Subject: Docket Nos. 50-361 and 50-362
Request for Geological and Seismic Information
San Onofre Nuclear Generating Station
Units 2 and 3

RESPONSE TO NRC REQUEST FOR INFORMATION
GEOLOGIC AND SEISMIC ISSUES
SAN ONOFRE NUCLEAR GENERATING STATION

Woodward-Clyde Consultants and Geomatrix Consultants, Inc. prepared the following responses to NRC's request for geological and seismic information for San Onofre Nuclear Generating Station. The responses pertain to the probabilistic seismic hazard assessment performed in 1994 for San Onofre (SONGS PSHA). The SONGS PSHA report is the "Seismic Hazard at San Onofre Nuclear Generating Station, Final Report," dated August 25, 1995 and prepared by Geomatrix Consultants, Inc., Risk Engineering, Inc., and Woodward-Clyde Consultants.

Fig. 1-1

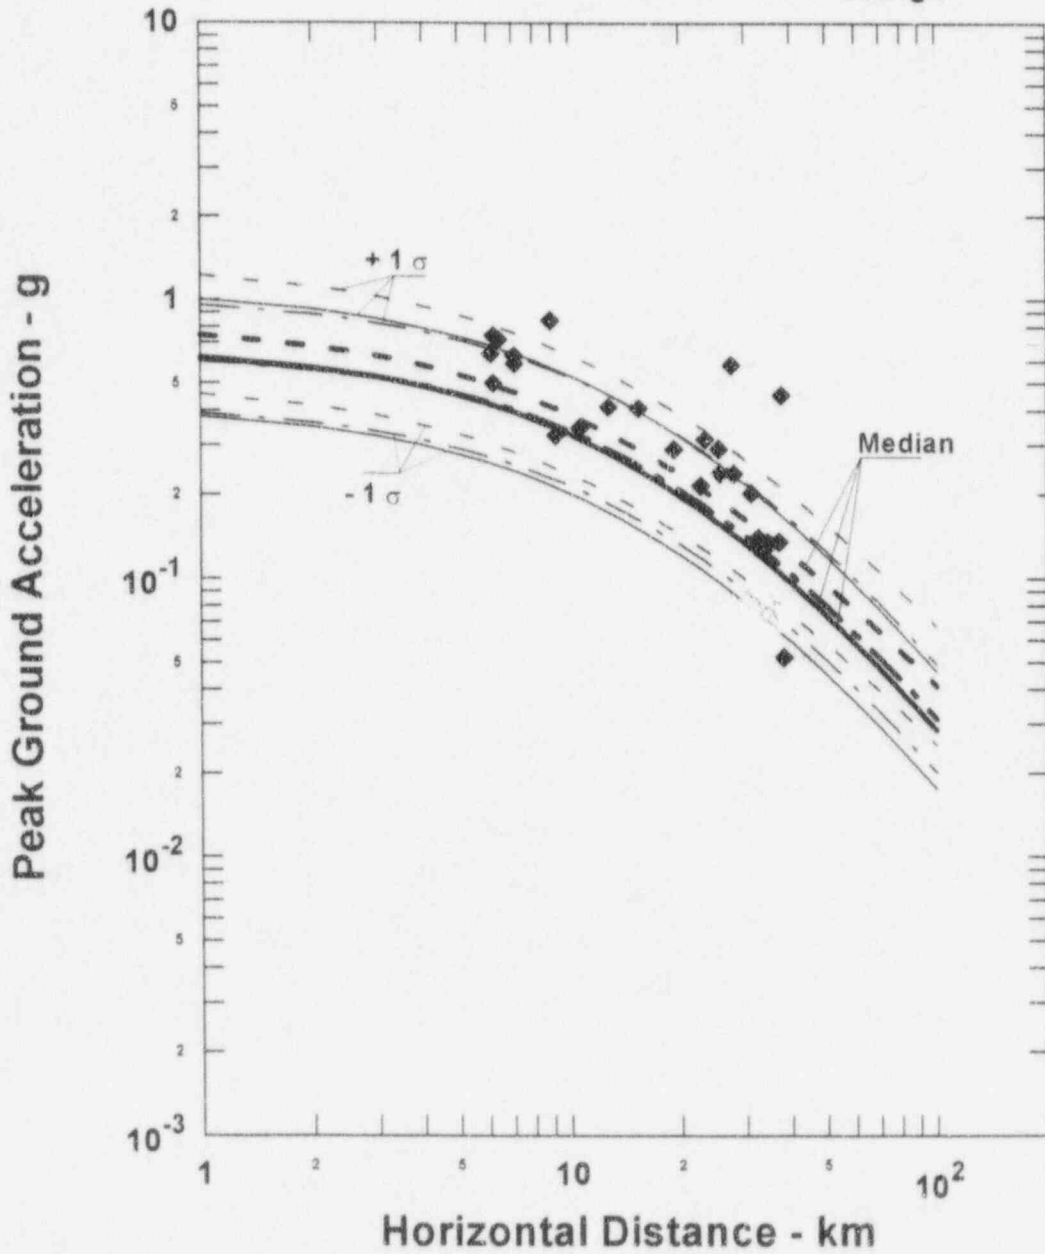
"Five empirical ground motion attenuation functions were used by the estimation of the probabilistic seismic hazard at San Onofre Nuclear Generating Station (SONGS) for the Individual Plant Examination for External Events (IPEEE) program. Did the development of these functions include data from recent southern California earthquakes such as the Northridge and Landers events? If not, how do the estimates of ground motion using these functions compare with the data recorded from these two events?"

The Northridge event was a thrust or reverse event, not a strike-slip event, and, therefore, was considered not pertinent for the evaluation of attenuation relationships for the purposes of the SONGS PSHA. Even in 1994, it was well established that thrust or reverse events result in ground motions that are different from those due to strike-slip events, and mixing them in assessing attenuation relationships mainly for strike-slip events likely would be misleading.

Nevertheless, because Question 1 mentions the Northridge event, Figure 1-1 compares the peak ground acceleration versus distance from three of the attenuation relationships using the soils site data from the Northridge event. The median as well as plus-and-minus one standard deviation relationships for thrust or reverse events are shown on Figure 1-1. As can be seen from Figure 1-1, the three attenuation relationships appear to be reasonably compatible with the Northridge event data with most data plotting between the median and $+1\sigma$ attenuation curves, even though they are considered to be not pertinent to the SONGS site.

Fig. 3-1

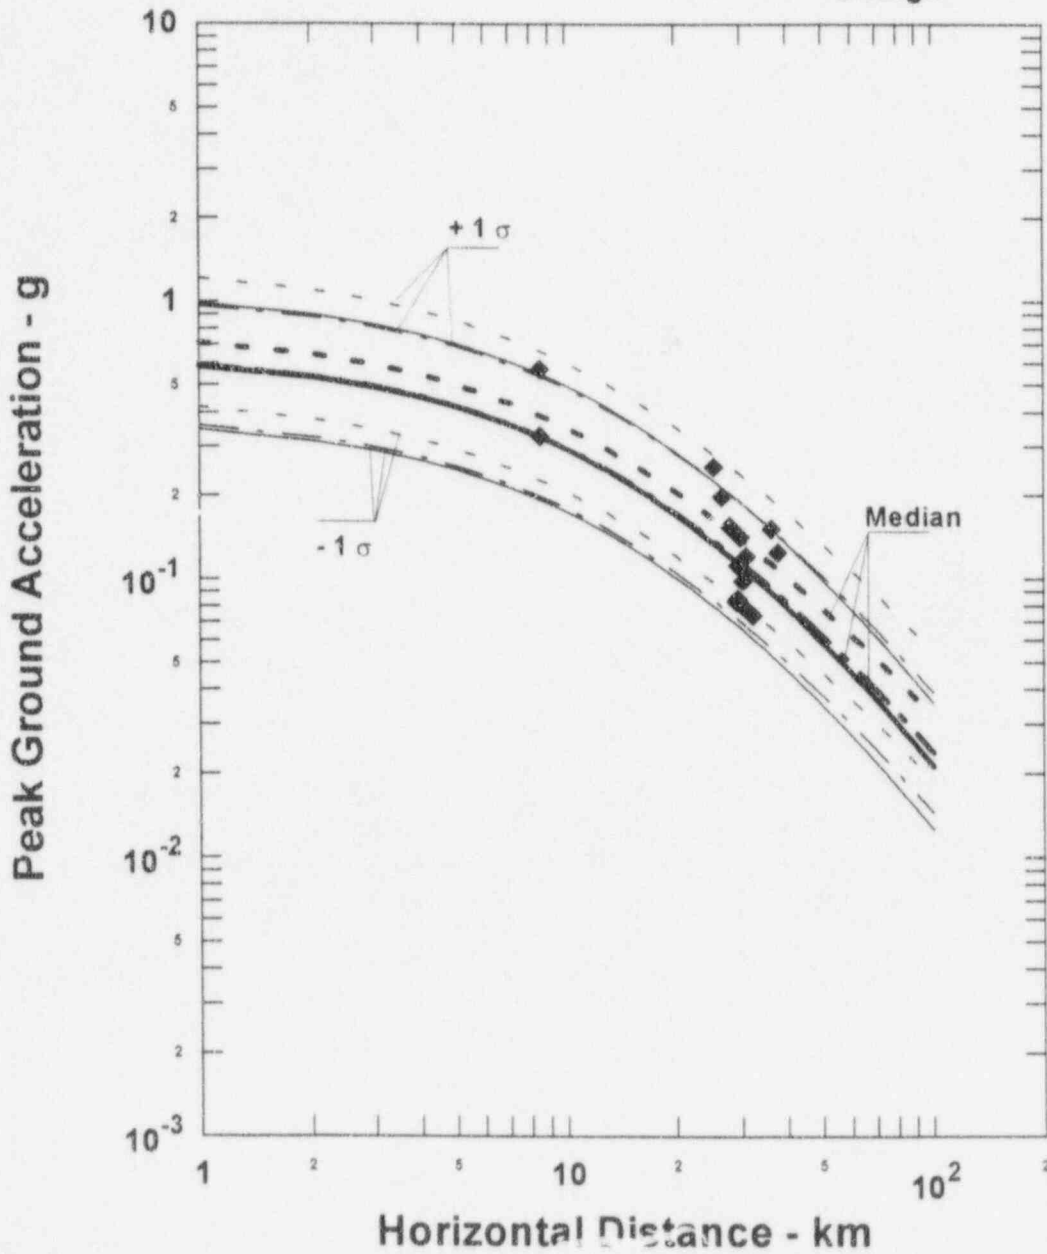
"Provide any assessment of the ground motion at the SONGS site from a magnitude 7 earthquake on the South Coast Offshore Zone of Deformation at a distance of 8 kilometers. Did any such assessments consider the ground motions recorded from earthquakes that have occurred since the licensing of SONGS, Units 2 and 3, such as those at Coalinga, Petrolia, Loma Prieta, Landers and Northridge?"

As discussed above and in the response to Question 1, the attenuation relationships used in the study, which form the basis for the ground motion assessment at the site, are quite consistent with the Landers, Northridge, and Loma Prieta events. The Coalinga (magnitude 6.4) and Petrolia (magnitude 7) events like the Northridge event are reverse and thrust events, respectively, making them not pertinent to the strike-slip focus for the SONGS site.

Since Question 3 mentions the Coalinga and Petrolia events, Figures 3-1 and 3-2 compare the peak ground acceleration versus distance from three of the attenuation relationships using the soils site data from the Coalinga and Petrolia events, respectively. The median as well as the plus-and-minus one standard deviation relationships for thrust or reverse events are shown on these figures. As can be seen from these figures, the three attenuation relationships appear to be reasonably compatible with the data from the Coalinga and Petrolia events with the data falling between $\pm 1\sigma$ of the attenuation relationships, even though they are considered to be not pertinent to the SONGS site.
